SR 92 Widening and Reconstruction from the Northpoint Parkway to the Cherokee Trail

Value Engineering Study Report

Final Design Development

re: Project Numbers NH-165-1 (40), Widening of State Route 92 from Woodland Road to Cherokee Trail and NH-165-1 (42), State Route 92 Widening from Northpoint Parkway to Woodland Drive in Cherokee County, Georgia
Value Engineering Study Report

AT QUAIL RUN (STA 95+373) SHEET NO.: 1 of 4

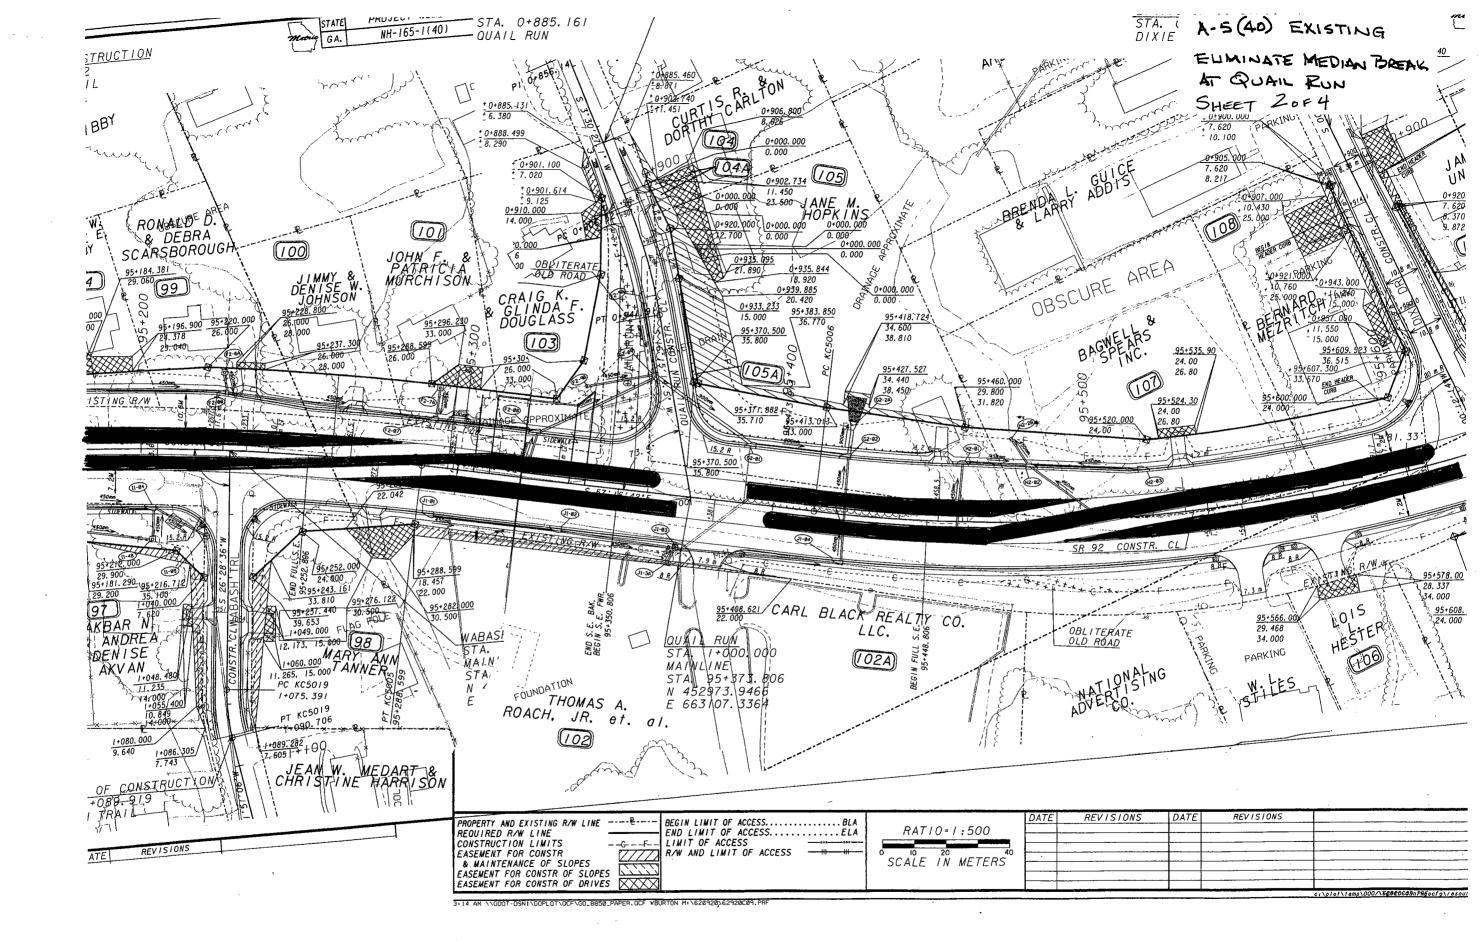
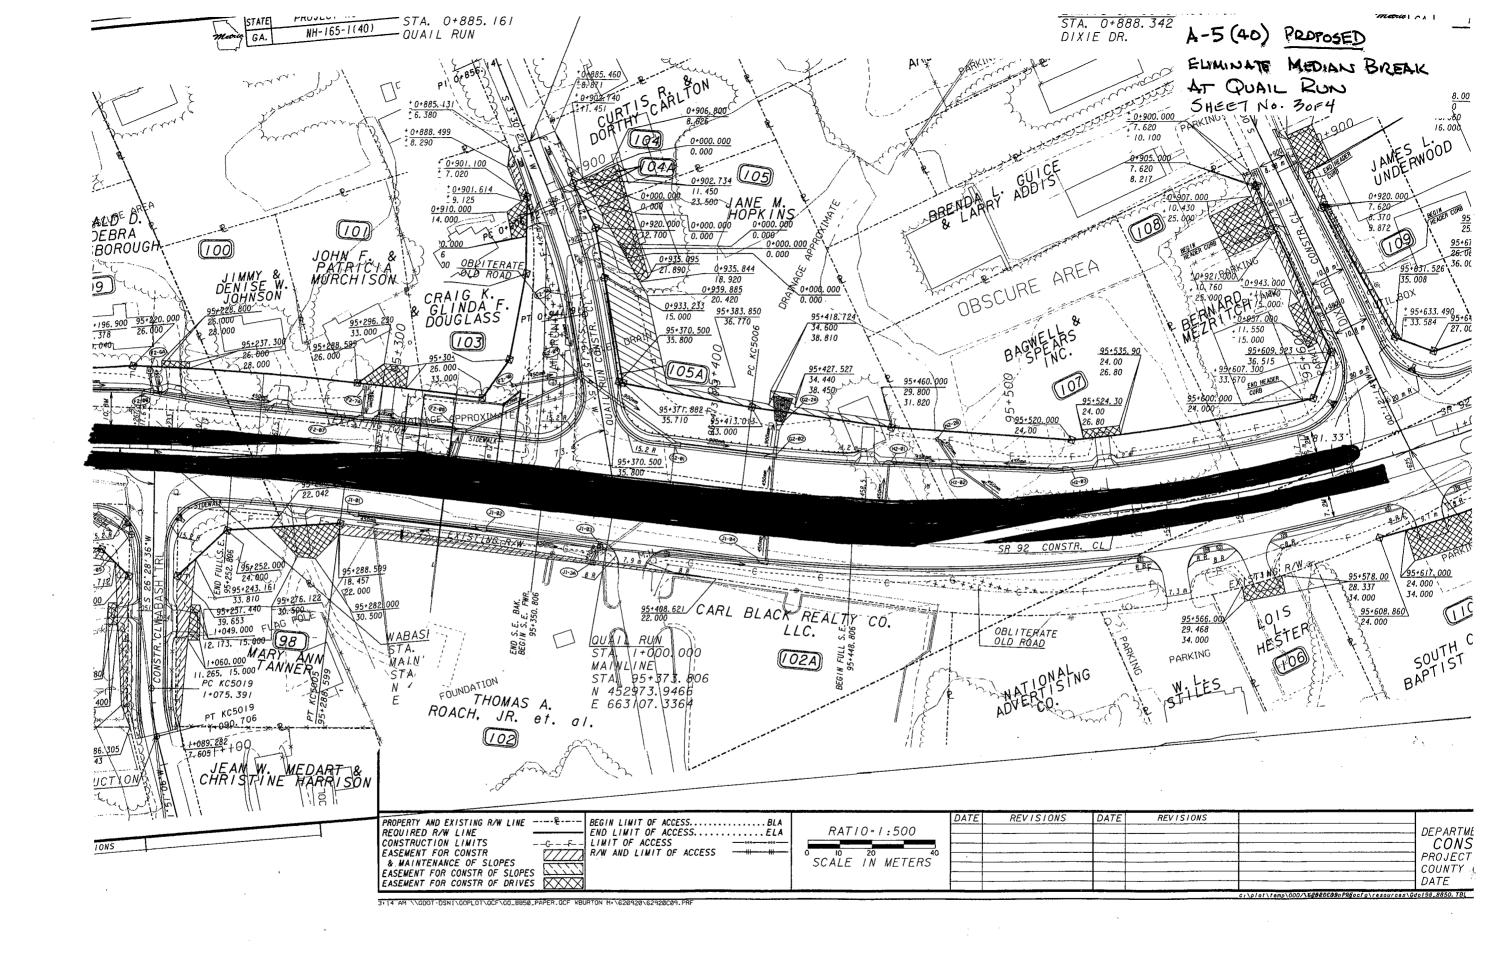
The planned configuration shows the start of the dedicated left-turn lane for Quail Run approximately 30 meters east of the Wabash Trail intersection. The planned configuration will tempt westbound drivers from Wabash Trail to cross both eastbound lanes and enter the left-turn/u-turn lanes in the space of 30 meters.

Eliminating the median break and the left turn lanes at Quail Run will reduce paved area by approximately 2,225 m² allowing for better drainage with less impervious area. This provides for a more environmentally friendly area of the corridor.

Eliminate the median break at Quail Run and direct the affected traffic to the u-turn lanes planned for Dixie Drive and Vicksburg Trail.
